PROJECT: Stockton CA Parking Garage
JOB NO: 1282
DRAWING NUMBER: D-12a

CUSTOMER TURNER CONST
 PROJECT ESSENTIAL SERVICES BLDG
 LOCATION STOCKTON, CA

ANCHOR BOLT LAYOUT GARAGE STAIRS

COFAB STEEL CORP. VALLEJO, CA	
CUSTOMER	TURNER CONST
PROJECT	PARKING GARAGE
LOCATION	STUCKTON, CA
LAYOUT GARAGE STAIRS	
DRAWN BY	HL
CHECKED BY	
APPROVED BY	
DATE	3-16-00
JOB NO	905 E7
DRAWING	
REV

CUSTOMER: TURNER CONST
 PROJECT: STOCKTON, CA
 LOCATION: WEST STAIRS LAYOUT GARAGE

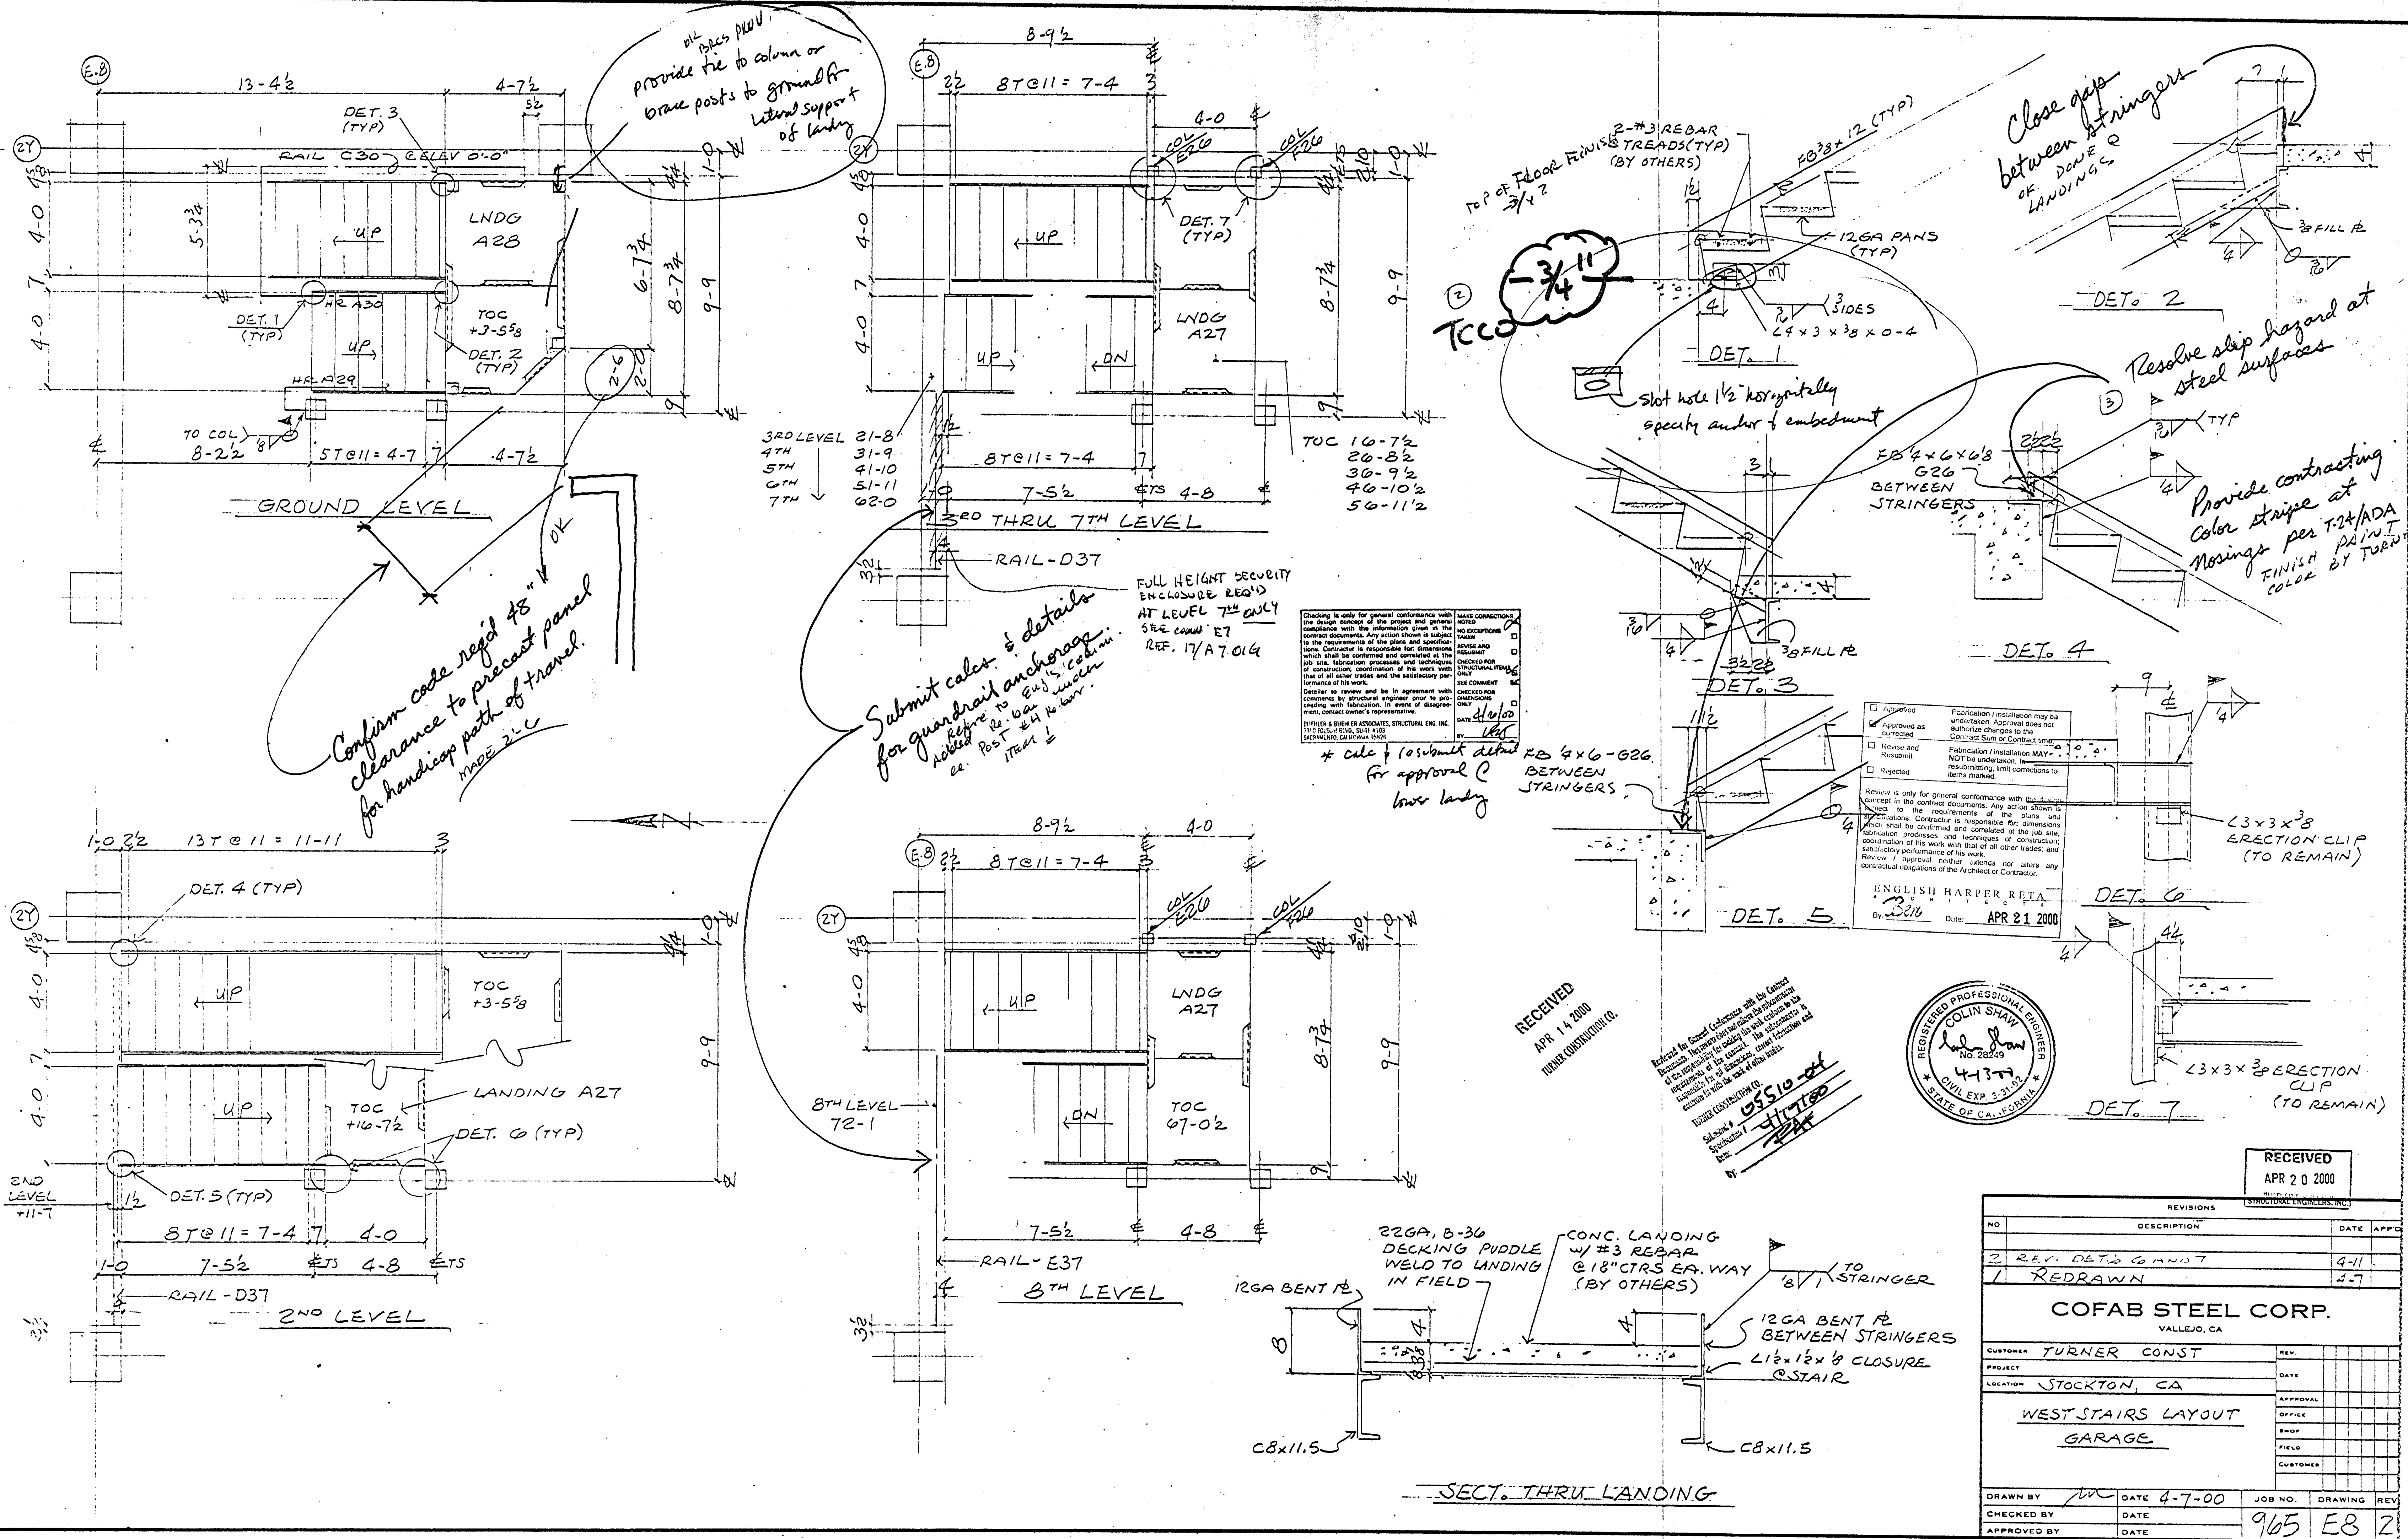
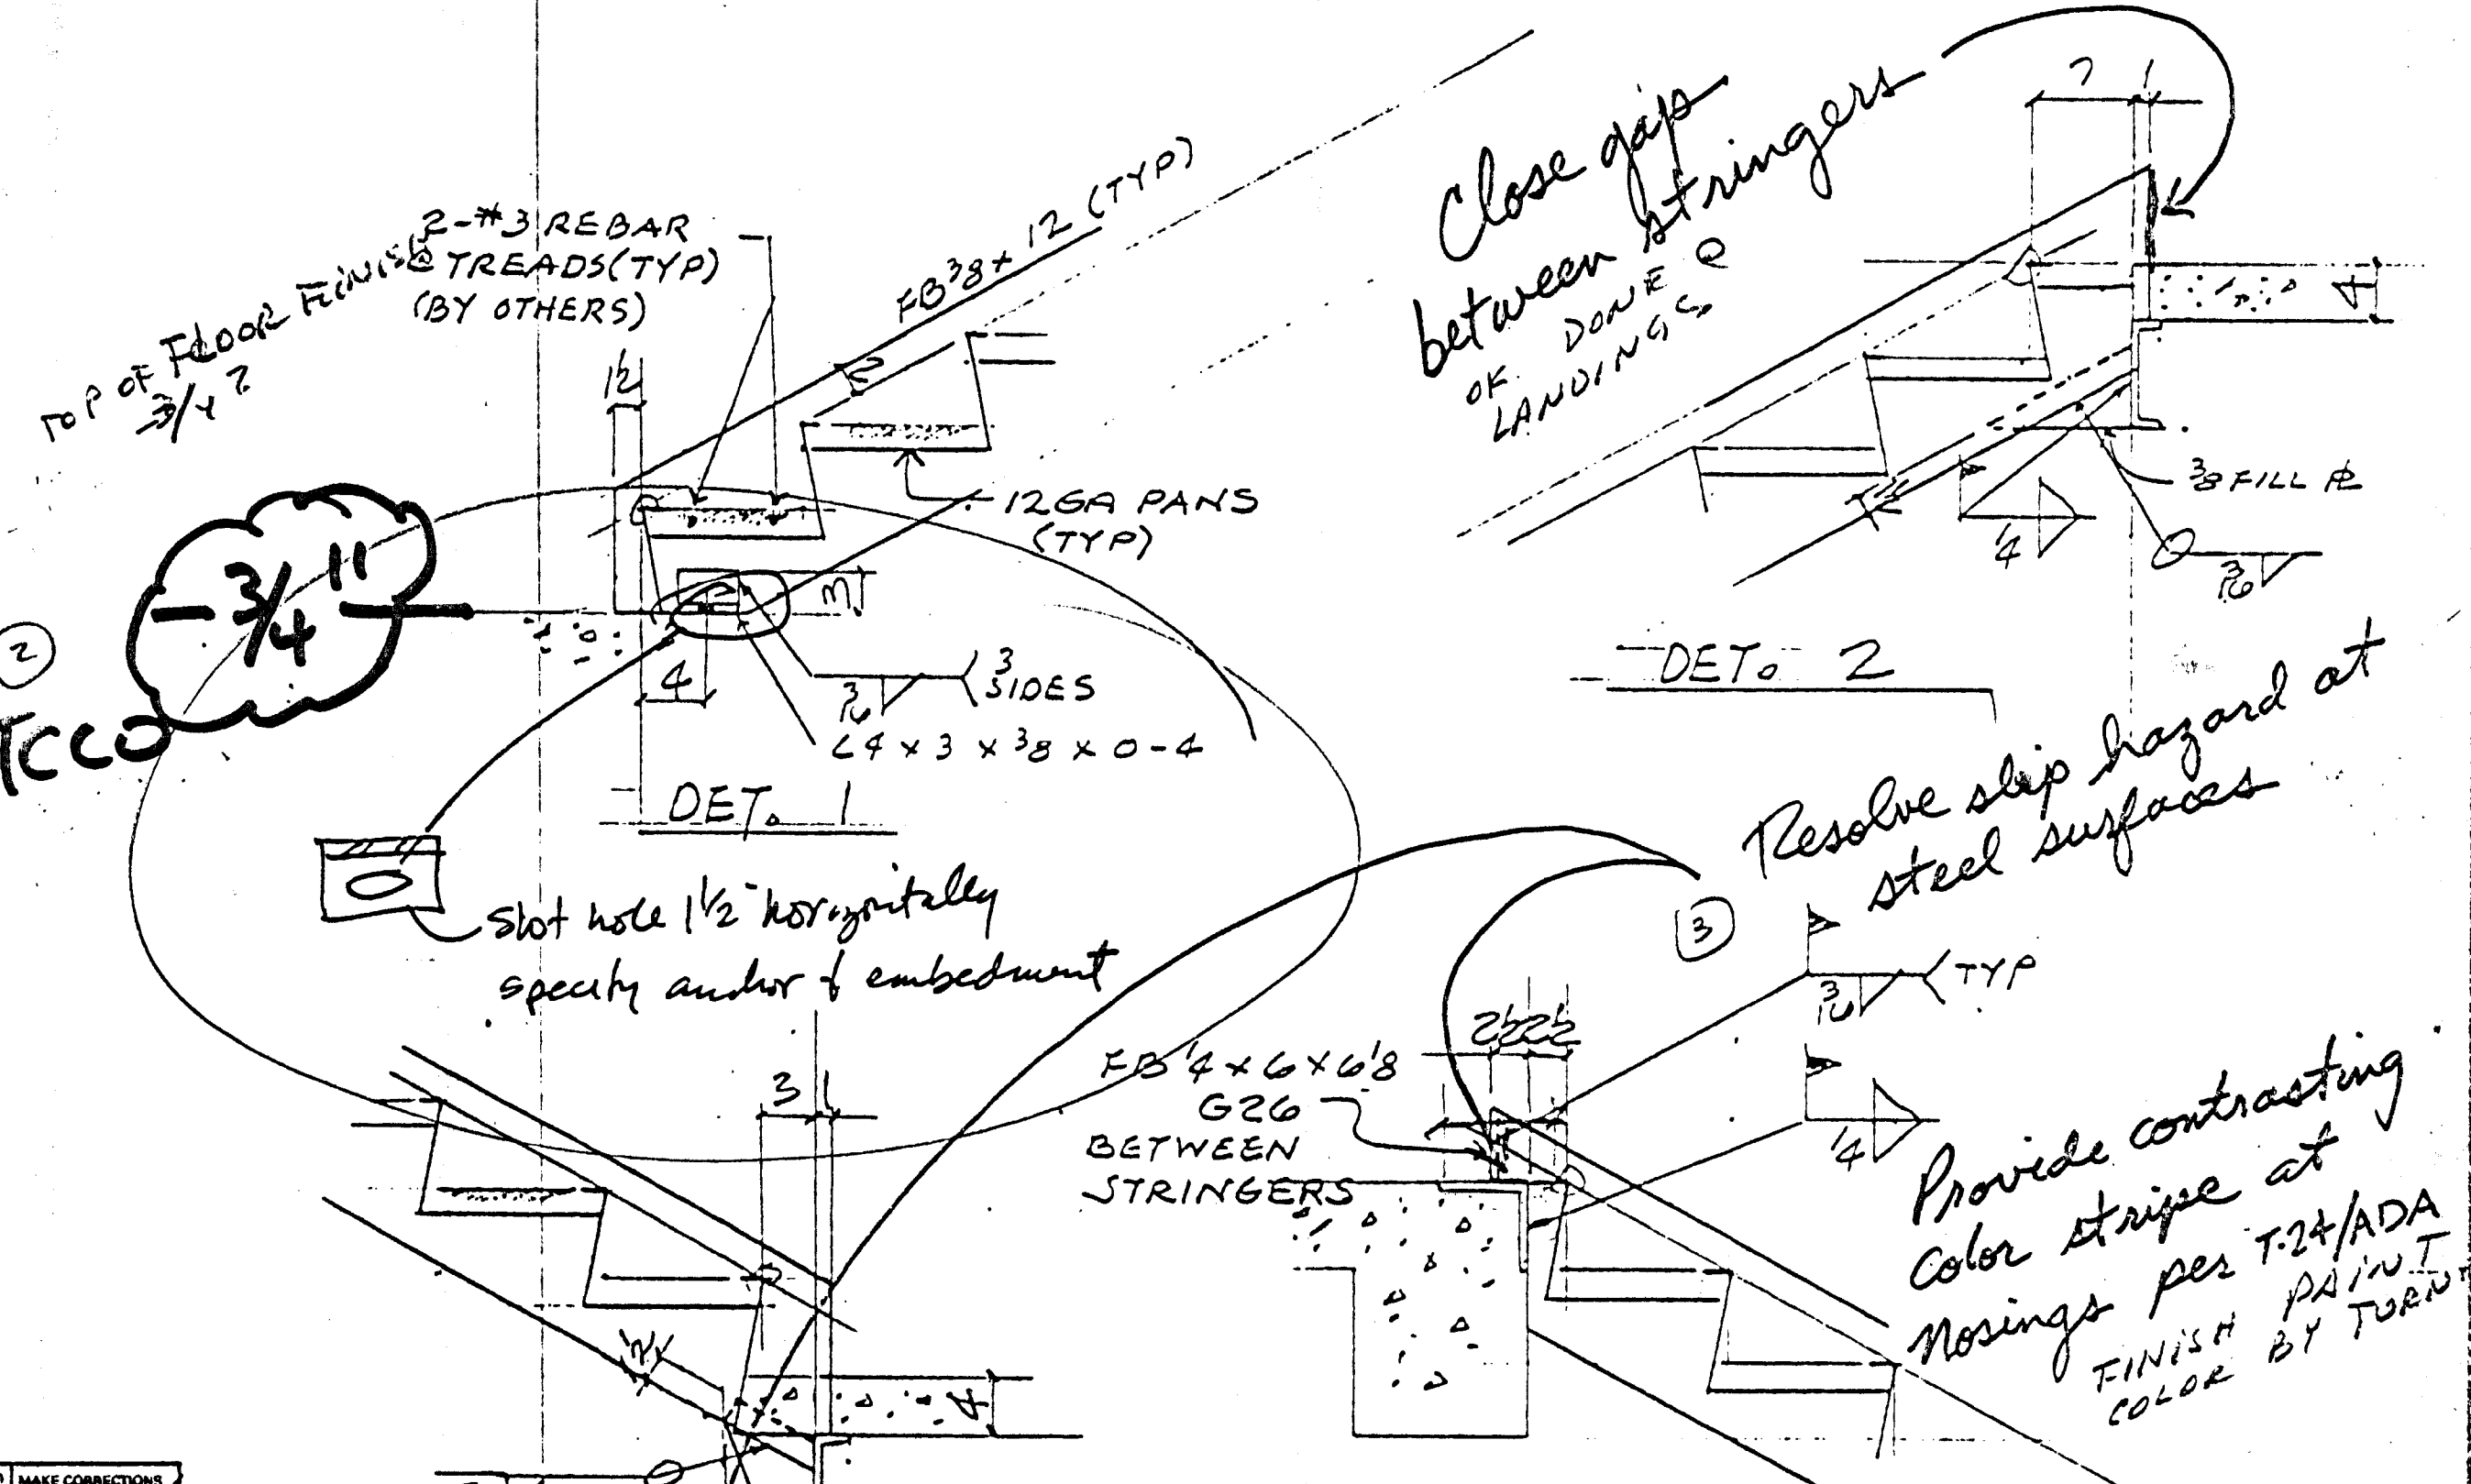
Turner should confirm

ALL PIPES PLUMB
 Provide tie to column or
 brace posts to ground for
 lateral support
 of landing

Confirm code req'd 48" w
 clearance to precast panel
 for handicap path of travel.
 MADE 2-1-00

Submit calc. & details
 for guardrail anchorage
 Refer to 6x15 column
 hold Post #14 Rebar
 ee. Tread 1/2"

FULL HEIGHT SECURITY
 ENCLOSURE REQ'D
 AT LEVEL 7TH ONLY
 SEE COMM E7
 REF. 17/A7.014

* Calc & submit detail for approval @ lower landing

DRAWN BY: [Signature] DATE: 3-21 JOB NO. DRAWING REV.
CHECKED BY: RM DATE: 4-13-00 405 D28
APPROVED BY: DATE:

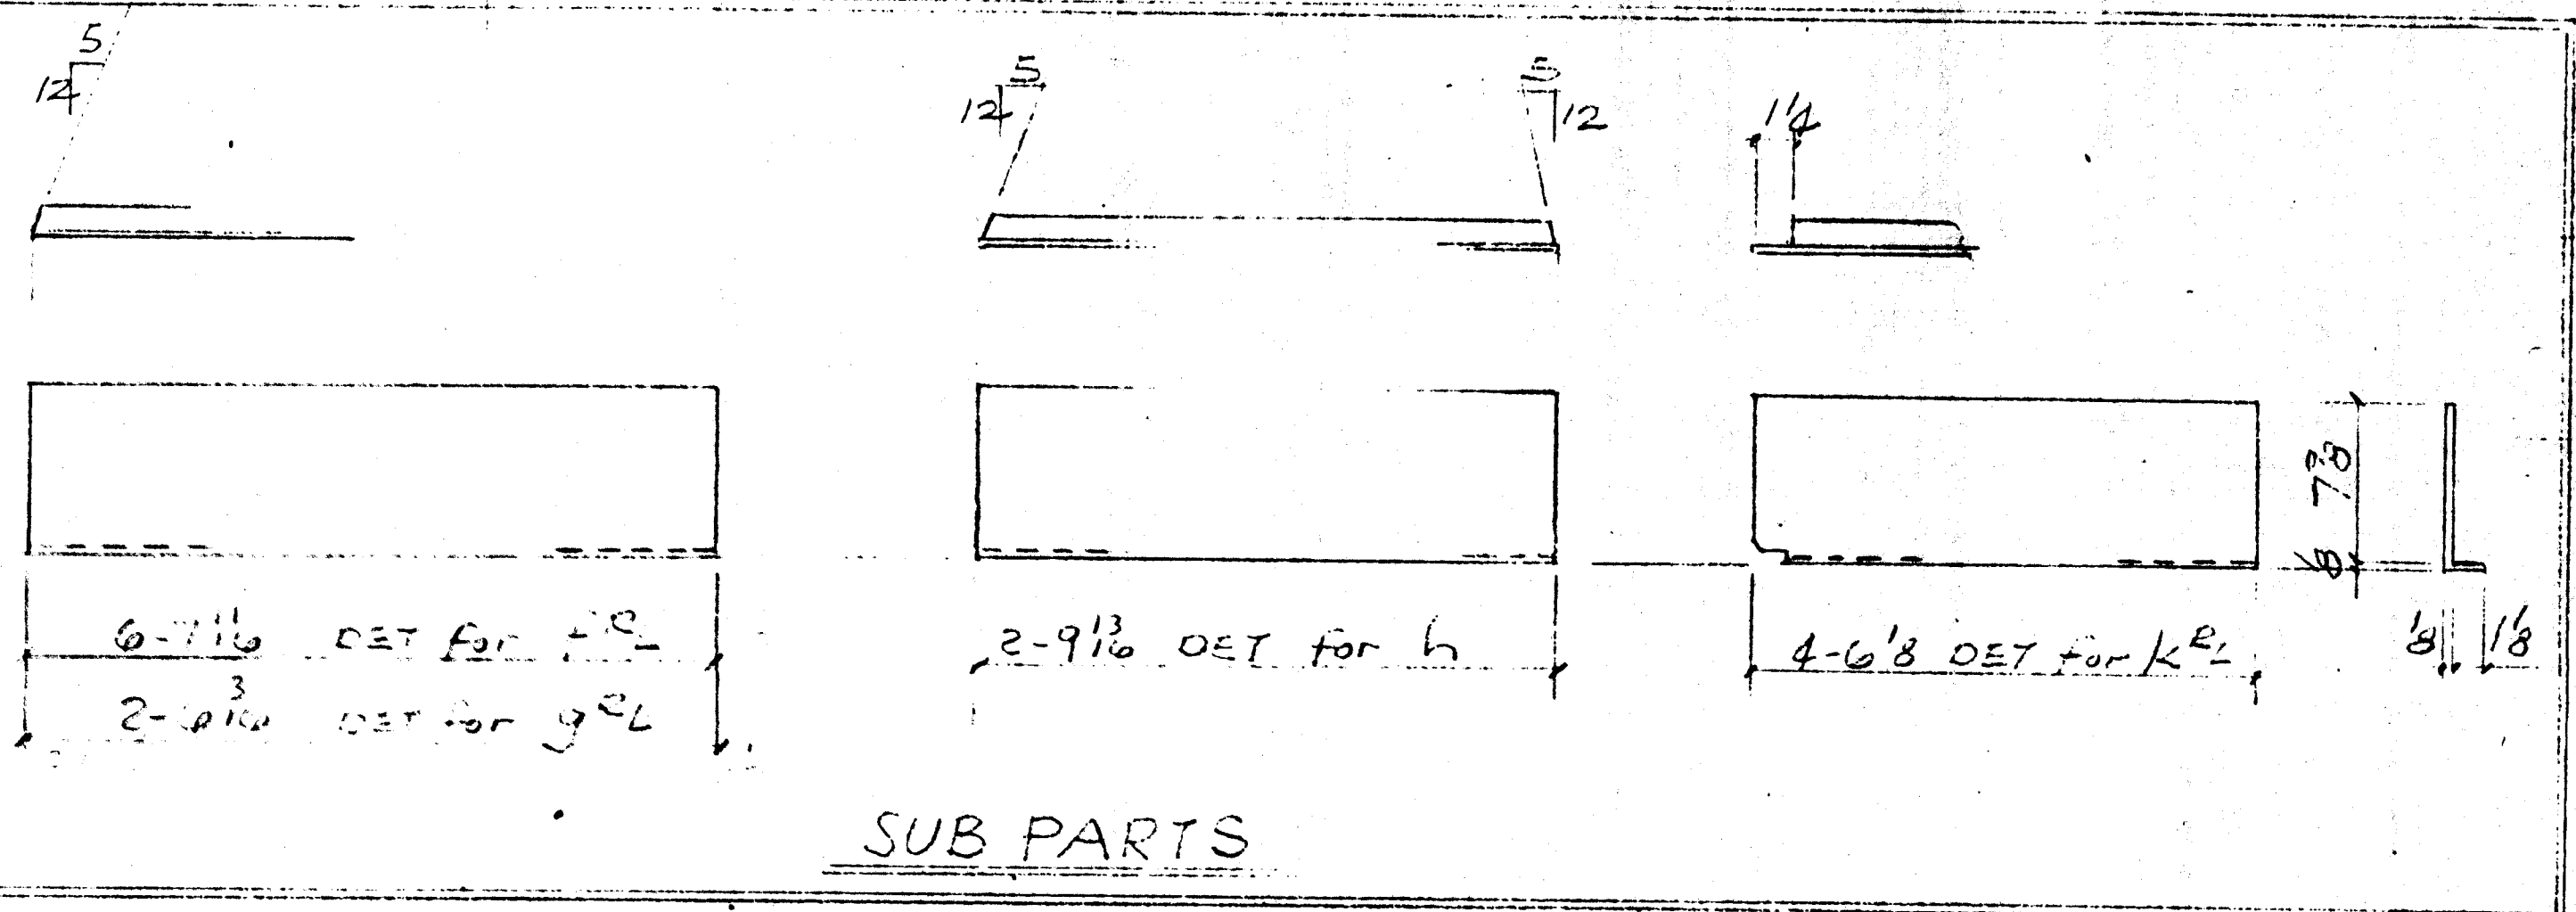
Turner should confirm...
exposed base plates are
trip hazard along handicap
path of travel -
IF SET AWAY FROM
WALK AREA
